Groundwater Application Review Summary Form

Application # G- 19281

GW Reviewer Andrew Wentworth/Travis Brown Date Review Completed: 07/05/2023

PUBLIC INTEREST REVIEW FOR GROUNDWATER APPLICATIONS

Well Locations Map

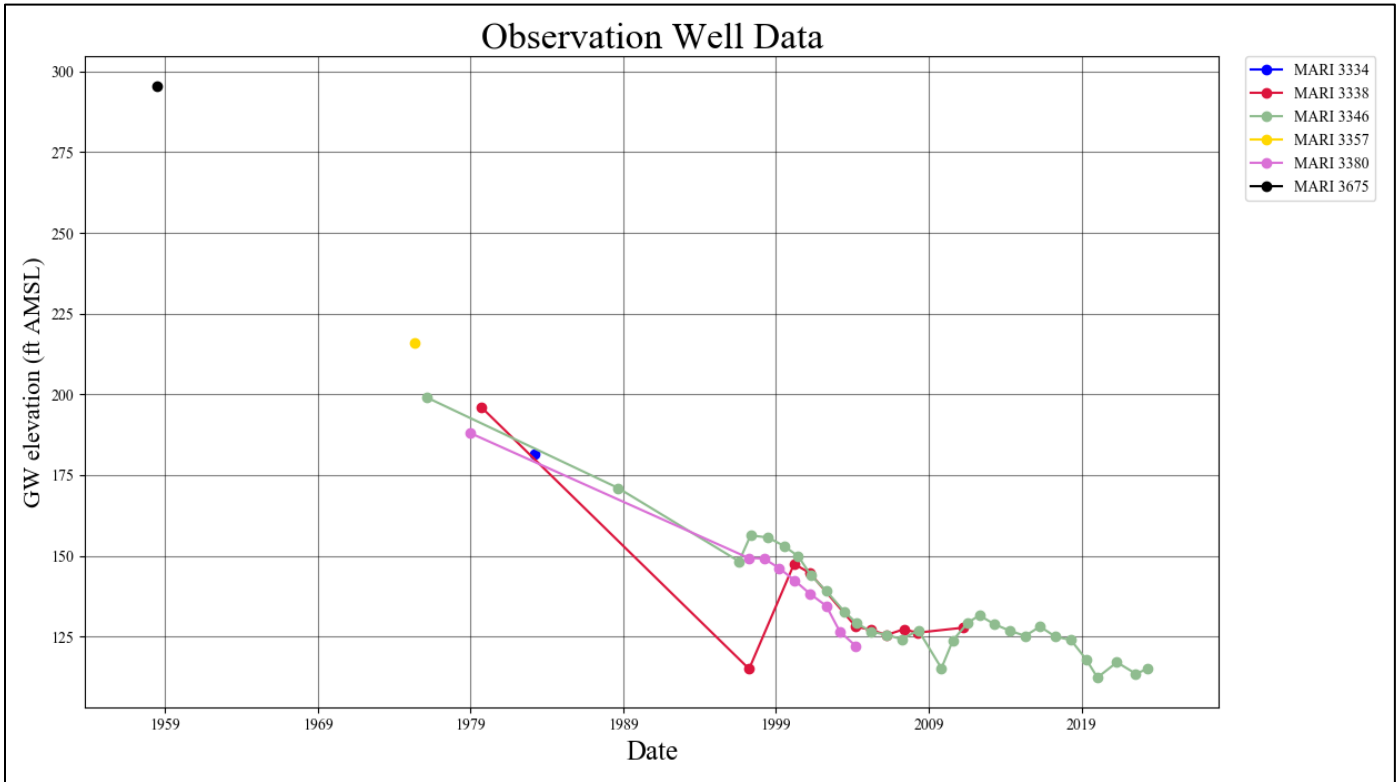
A4. **Comments:** ^aThere are small discrepancies in the metes and bounds description of the POA locations used by the applicant relative to the Department's Public Land Survey System (PLSS) projection and the locations as identified on the application map. The mapped location is considered to be the most accurate and will be used in this review.
